Draft Dundrum Local Area Plan 2023

Submission to Public Consultation

21st July 2023

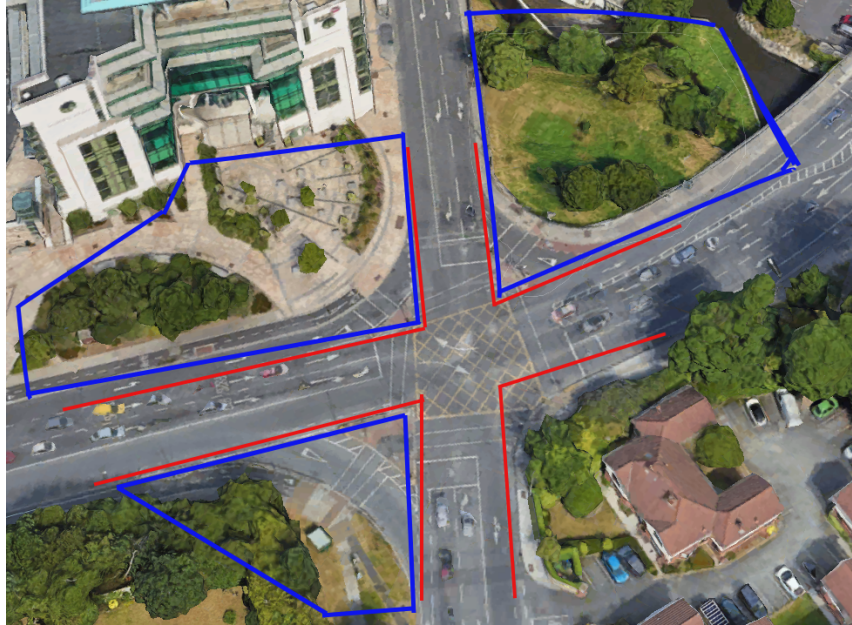
- With a reduction in roundabout/junction sizes especially along Wyckham Way, more space will be available for public realm, seating, low key play opportunities. I would ask that this is realised and includes taking some private areas in charge in order to make them more public-facing. An example is the below junction at Sandyford Road/Overend Way. The red line is a very rough sketch of space the new junction will take up and the blue shapes are where there could be opportunities to open up more space to the public.

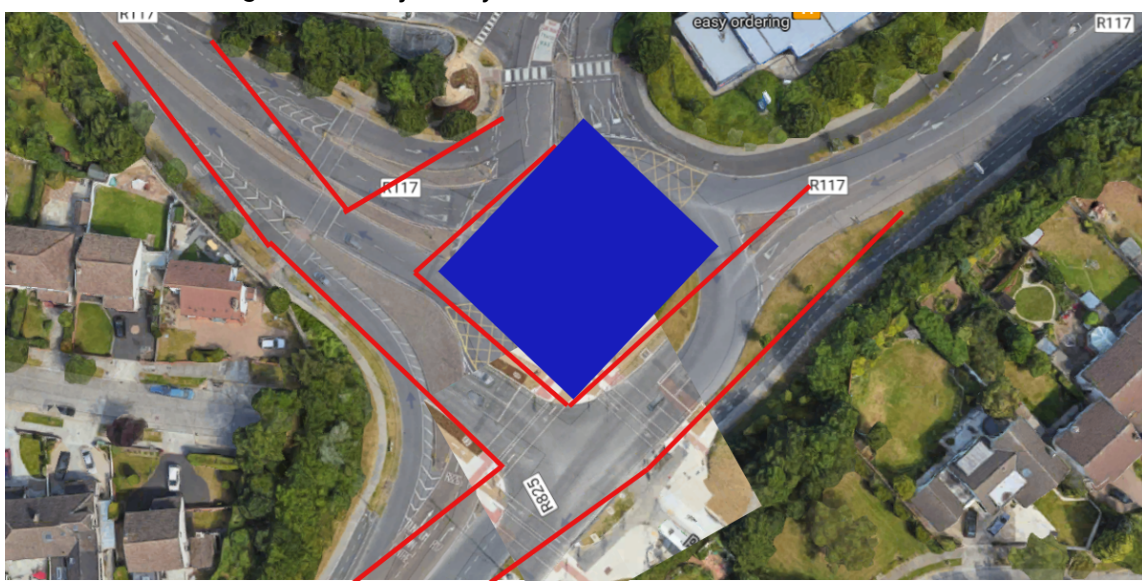
I would like to propose one potential area for a last-mile logistics hub. Above I have superimposed the size of the Drummartin Rd/Lower Kilmacud Rd junction onto the existing roundabout at the top of the Dundrum Bypass for scale. The red outline shows what could be the extent of the road. The blue box is the large amount of space left over that would be ideally placed for a last-mile logistics hub. Trucks would mostly arrive from the M50 or Sandyford. This would enable them to skip the village, the one way system and the bus gate.
